# Millstone Power Station

## *2000 Radioactive Effluent Release Report*

### Volume II

**MILLSTONE STATION**  
**RADIOLOGICAL EFFLUENT MONITORING AND OFFSITE DOSE CALCULATION MANUAL**  
**(REMODCM)**

FIGURE IC-2  
SIMPLIFIED LIQUID EFFLUENT FLOW DIAGRAM  
MILSTONE UNIT TWO

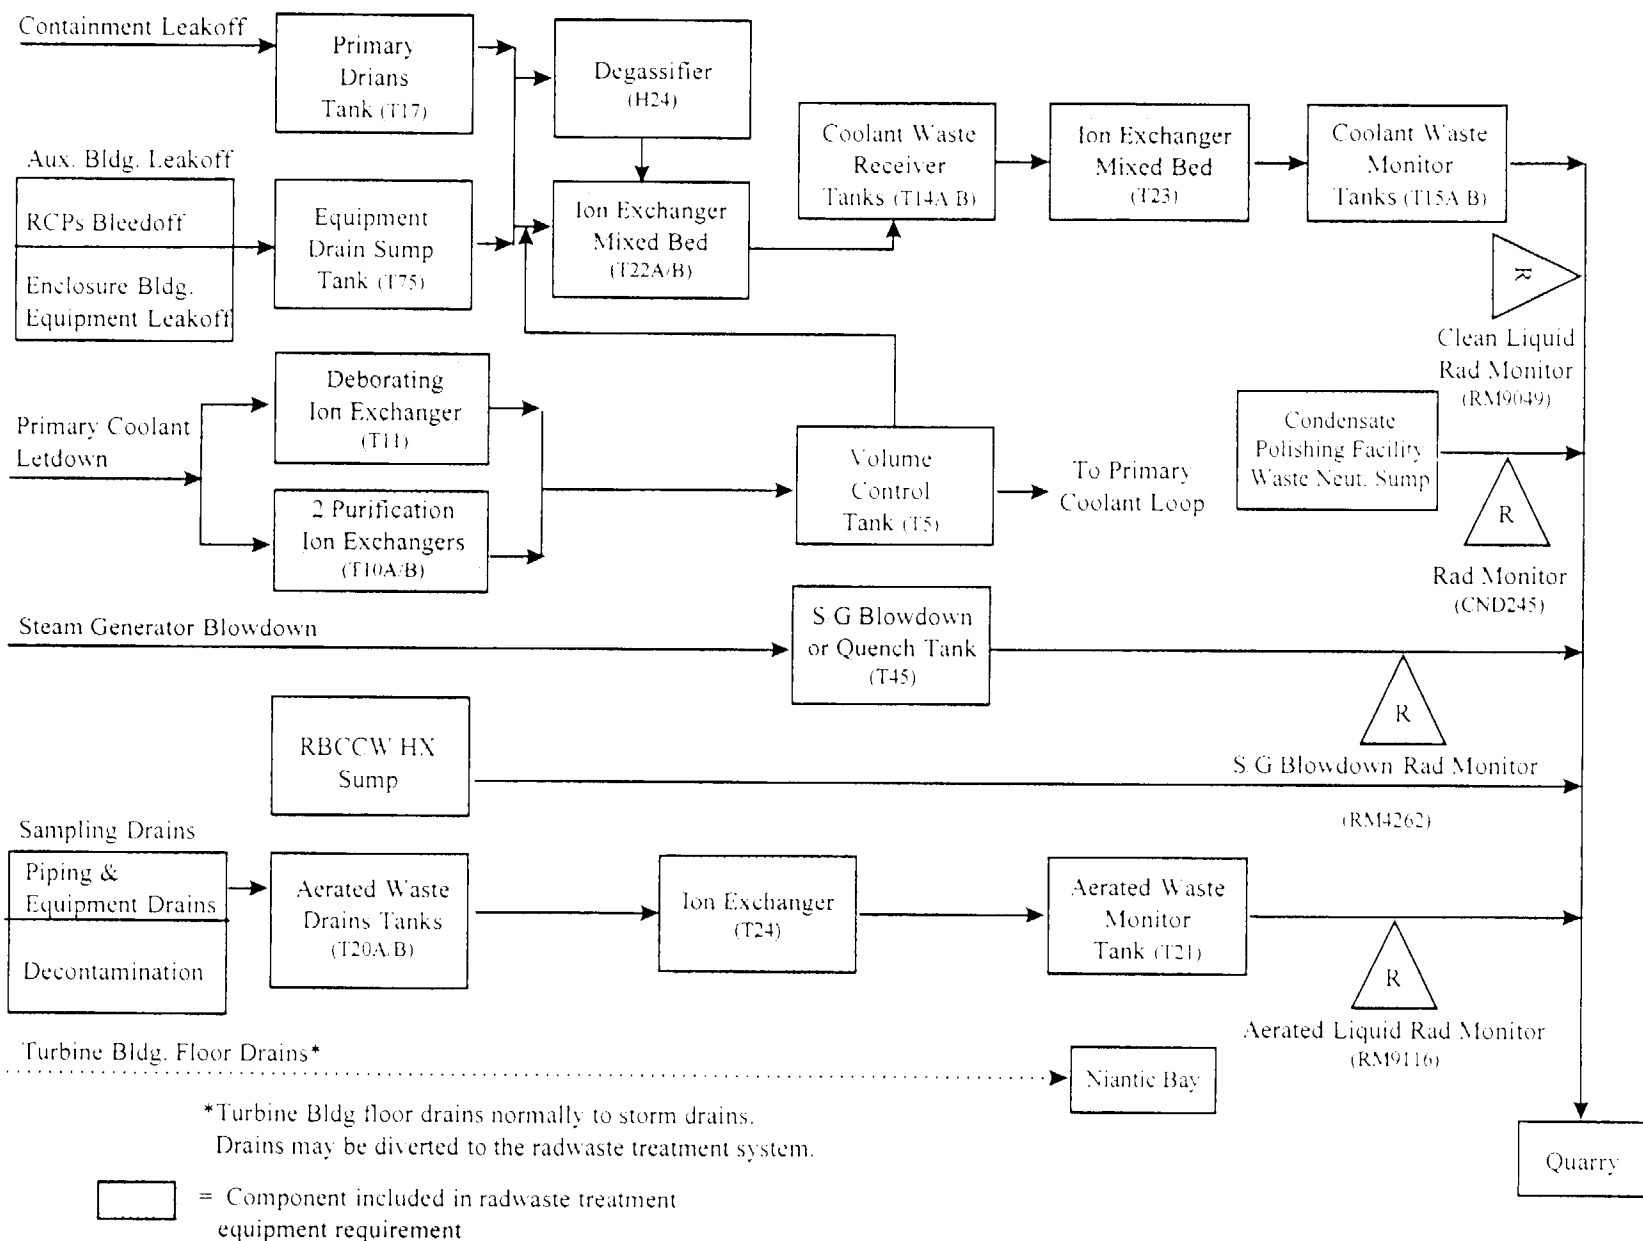
NEW

NEW

FIGURE 1D-2  
SIMPLIFIED AIRBORNE EFFLUENT FLOW DIAGRAM  
MILSTONE UNIT TWO

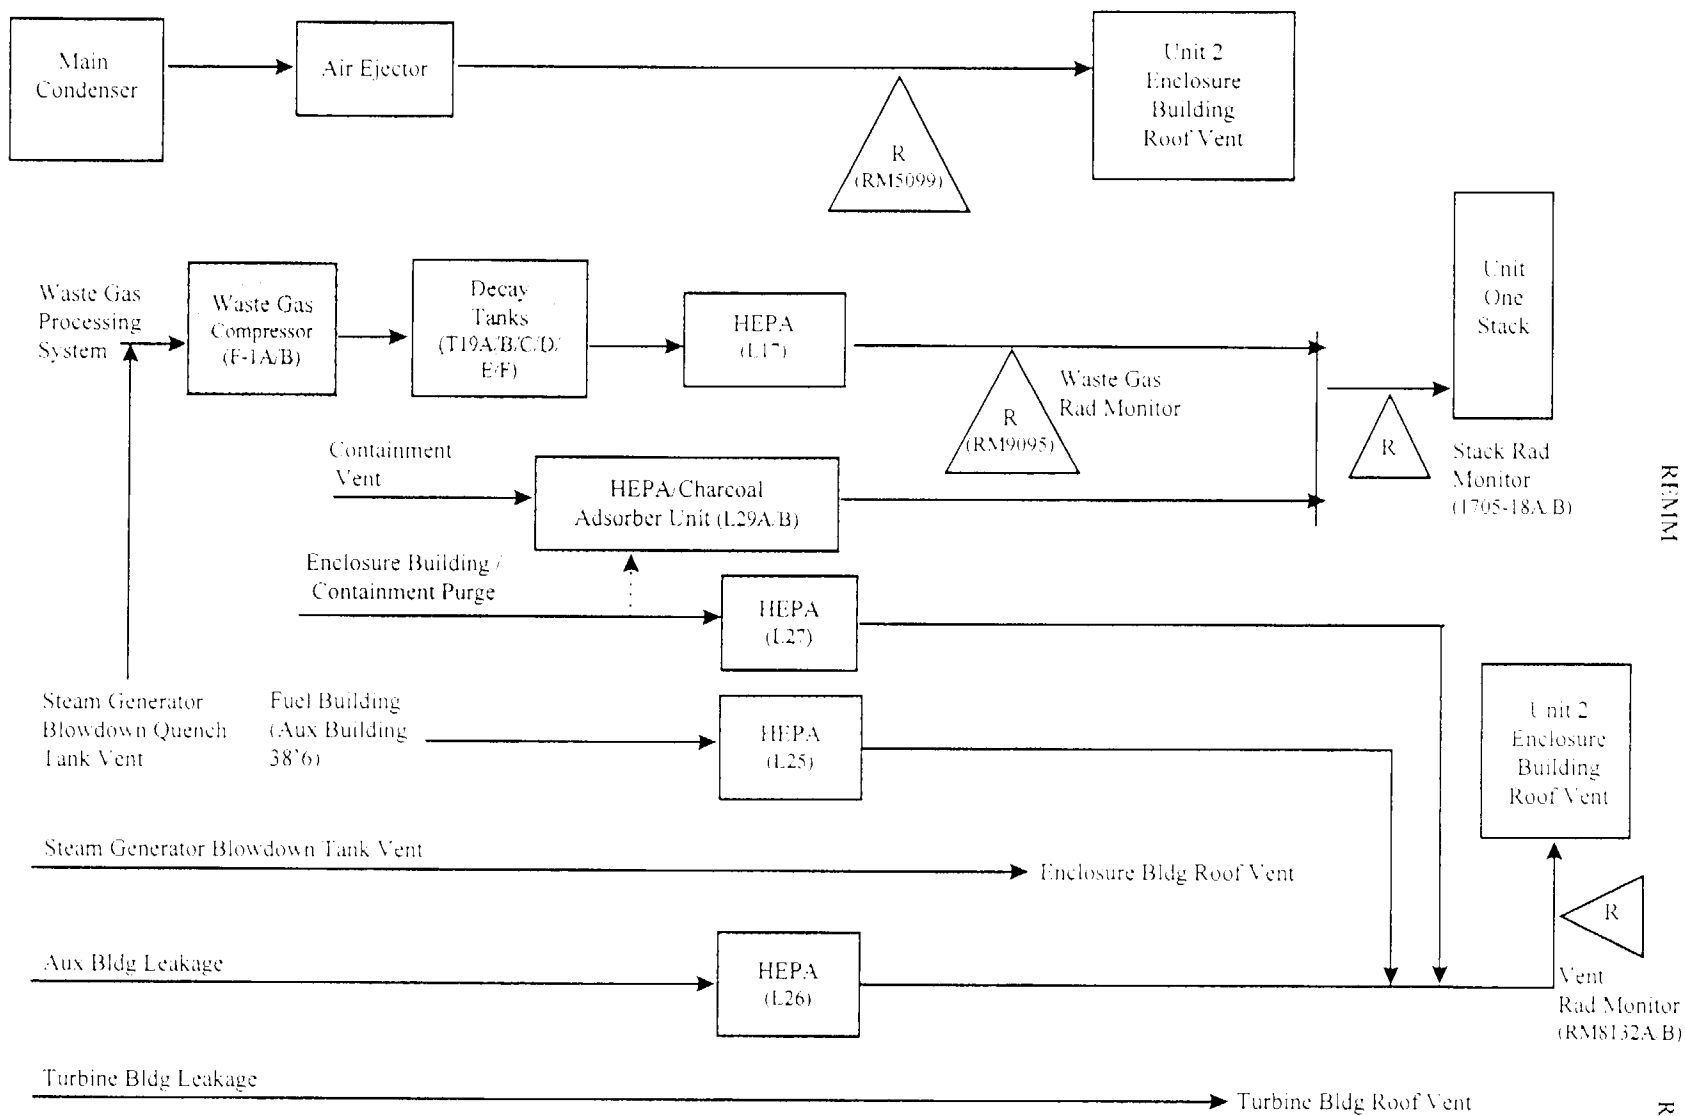
Revision 18  
NEW

NEW
